WATER PRODUCTION FACILITIES DISINFECTION SYSTEMS UPGRADE PHASE III

Solicitation No: CO-00384

ADDENDUM 2

Date: May 25, 2021

SHEET C-08
20 OF 167

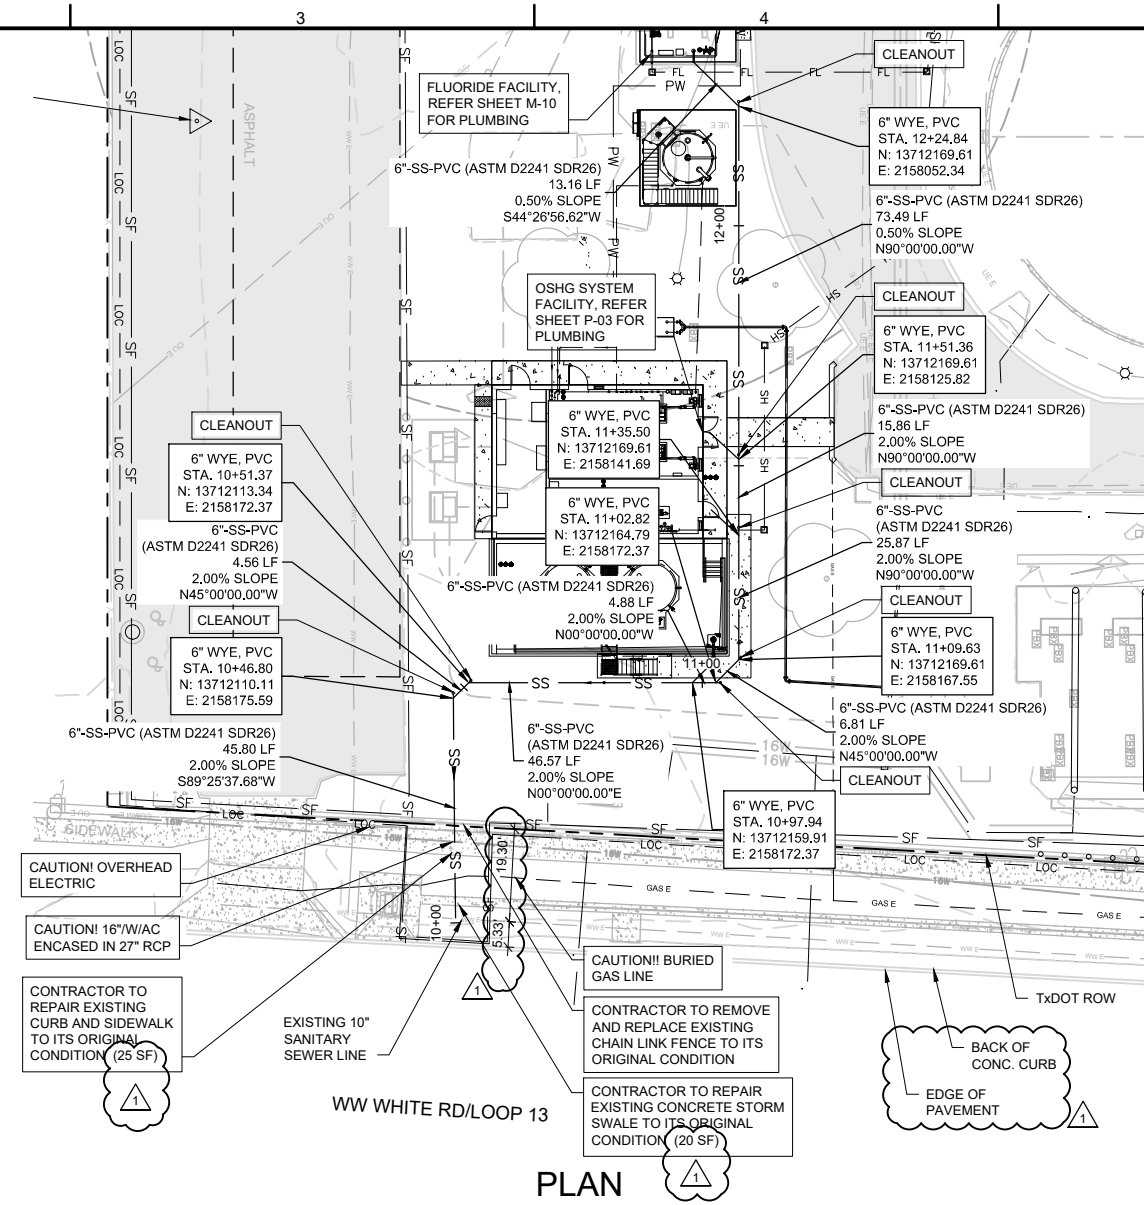
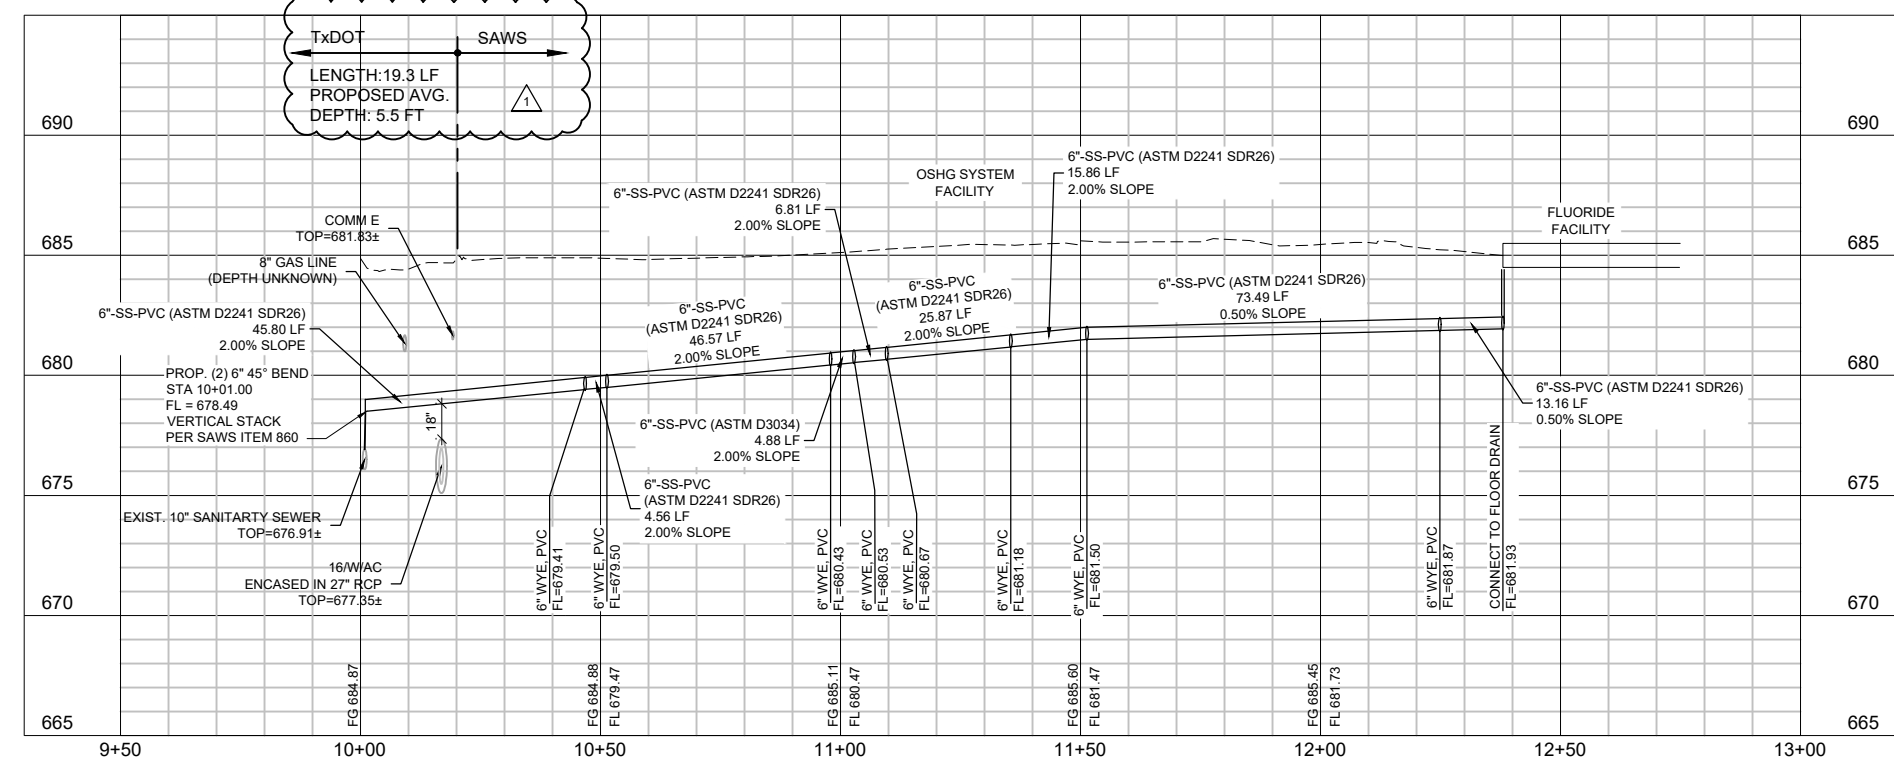
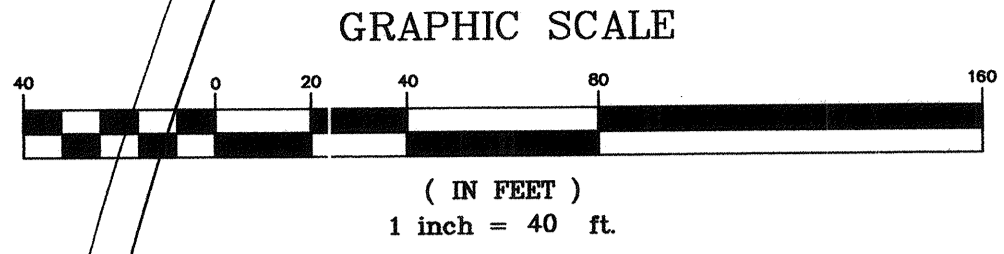
Delete Drawing C-08 and **replace** with revised Drawing C-08, attached. Roadway identified, edge of pavement and right-of-way delineated, and excavation length and depth within TxDOT ROW shown.

INDICATES PLAN OF RECORD		JPG	02-23-05
REVISIONS			
SERVICE LEVEL 5 (MICRON) PRIMARY PUMP STATION PROJECT			
SITE PLAN			
DEVELOPER:		BUDGET PROJ.	
SUBMITTED		APPROVED	
MAP No. 112-588	SECT. No. 22-Z 22-M	SHEET 2	
DR. J.N.M.	CK.B.G.	JOB No. 99-7023

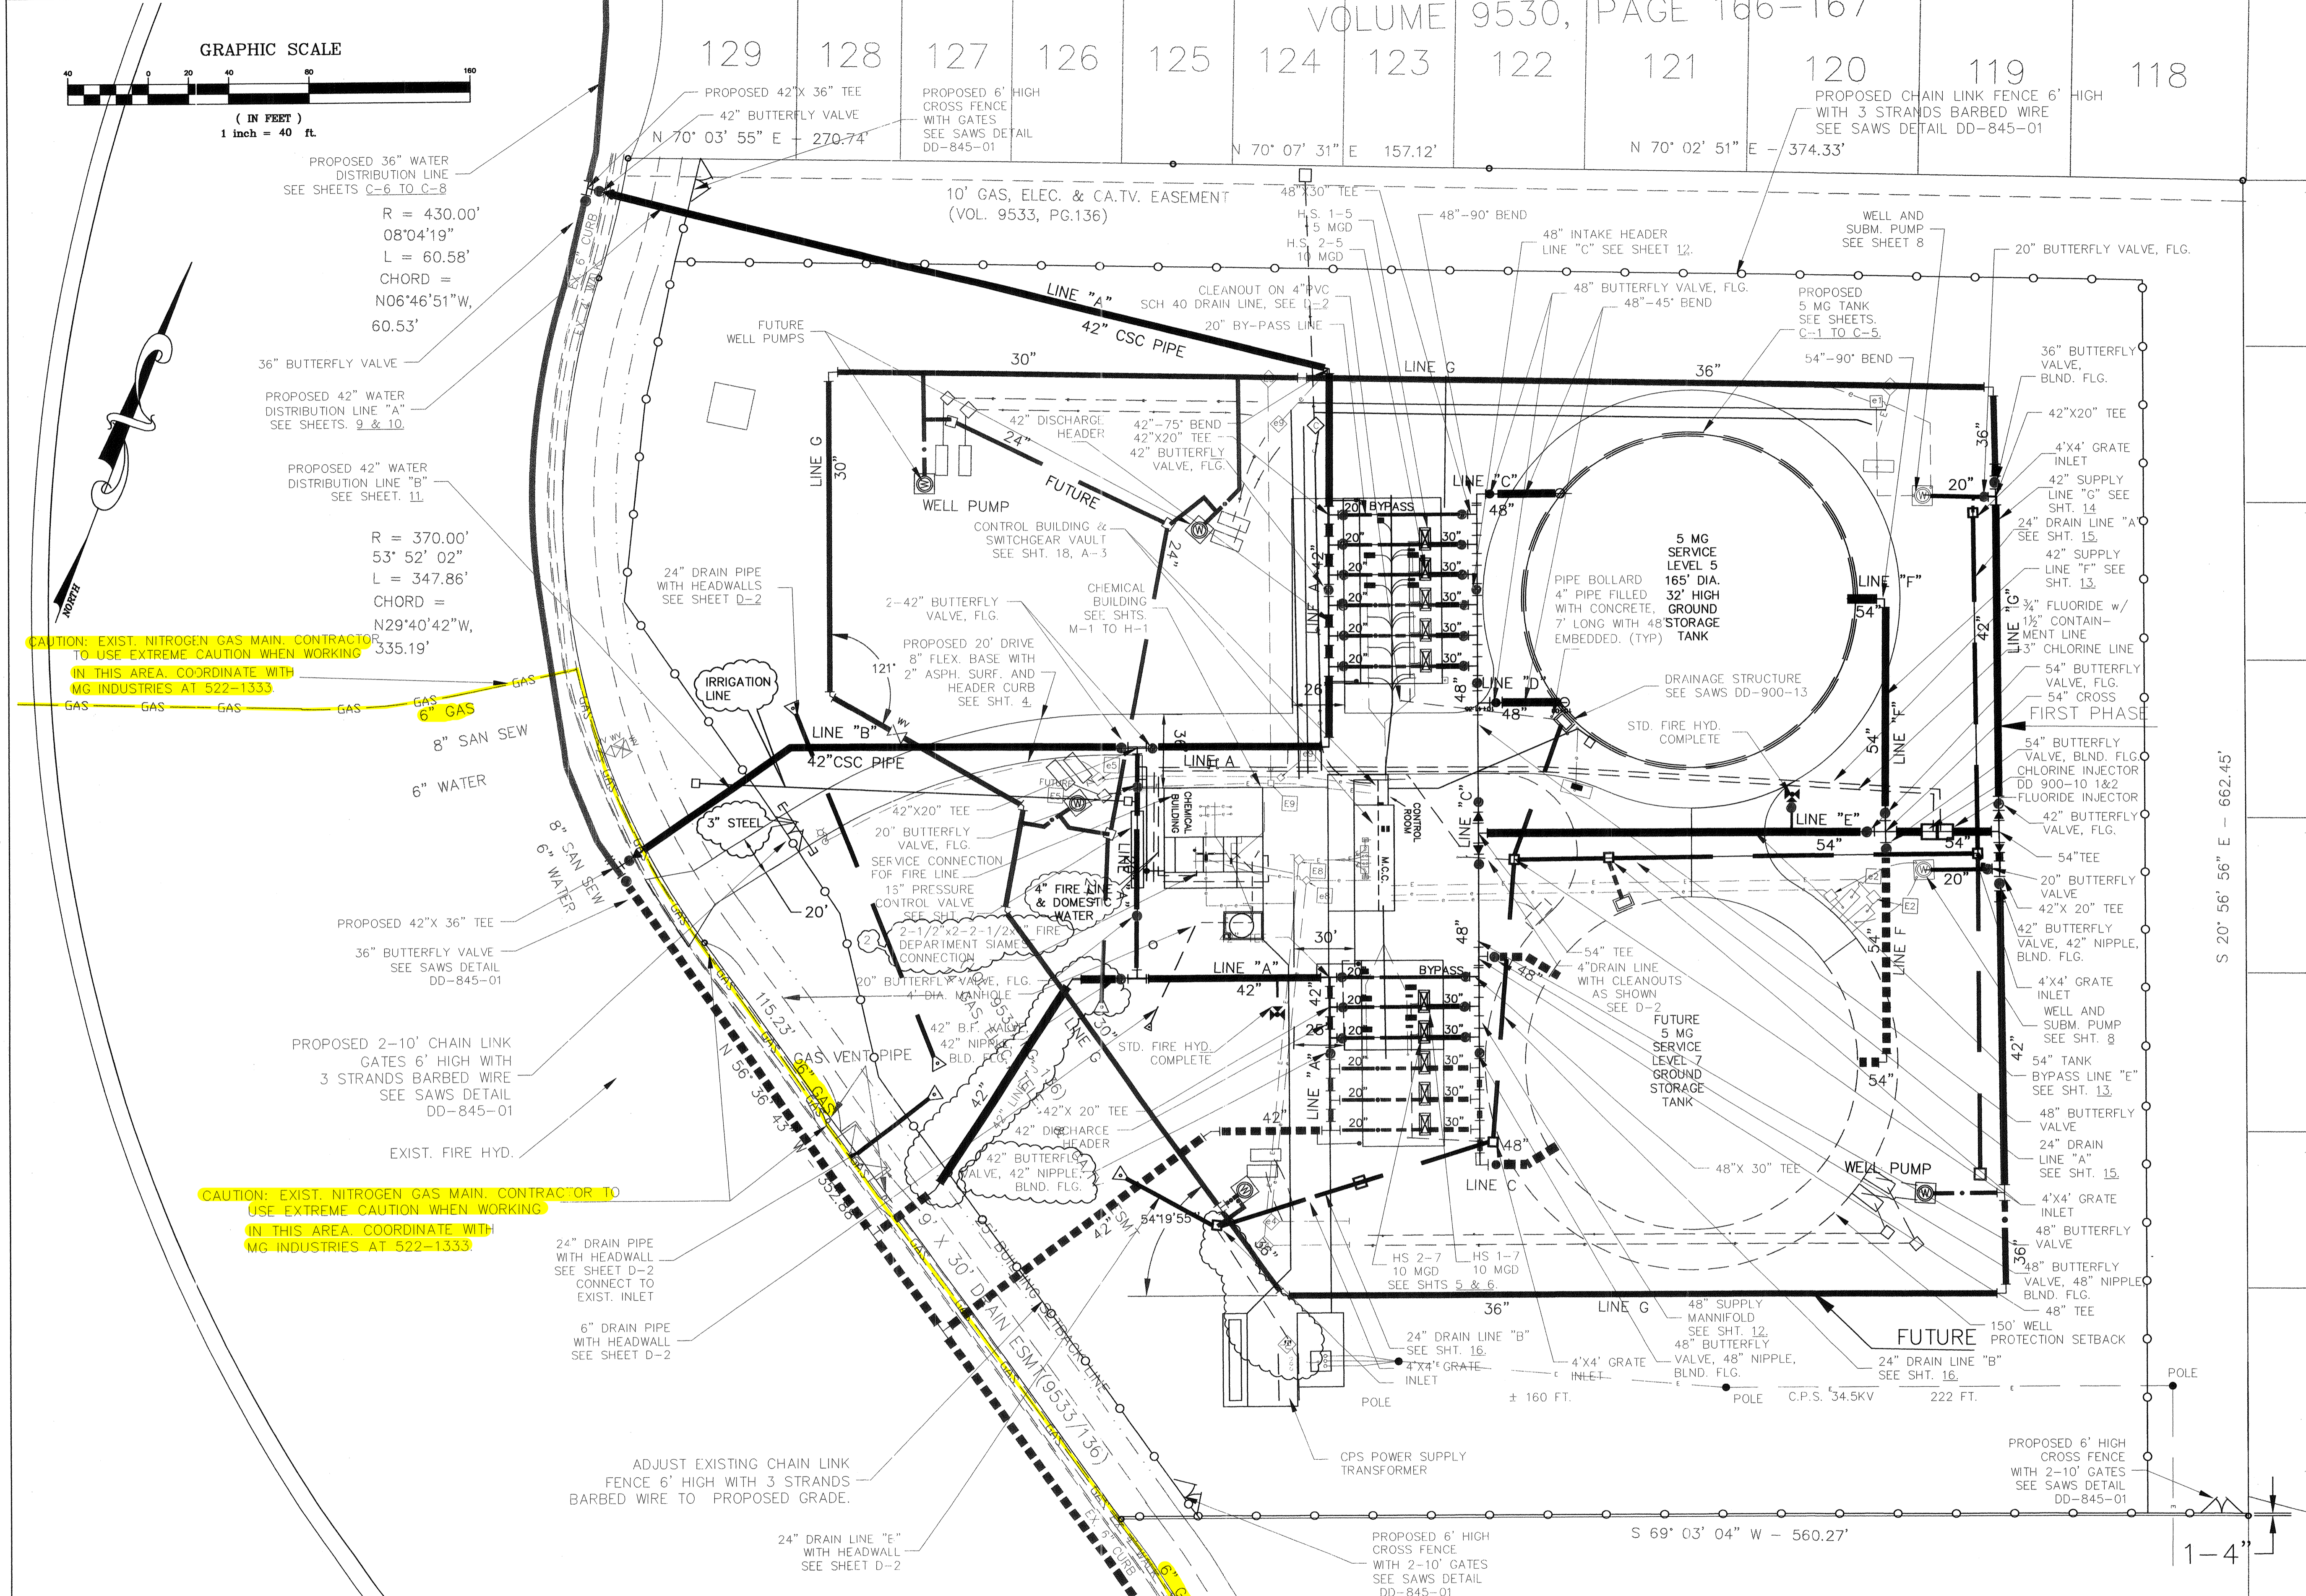
- 13. Question: Sheet C-03 – Please confirm that there is a nitrogen gas line to be crossed?**
Response: The gas line shown on Sheet C-03 is a nitrogen gas line to the best of our knowledge. SAWS provided as-builts (99-7023) which indicate this is a nitrogen gas line. Matheson Tri-gas owns a facility near the pump station and gas vent pipes are along Micron Road that appear to confirm the route of the nitrogen gas line shown on Sheet C-03. See the attached as-built site plan.
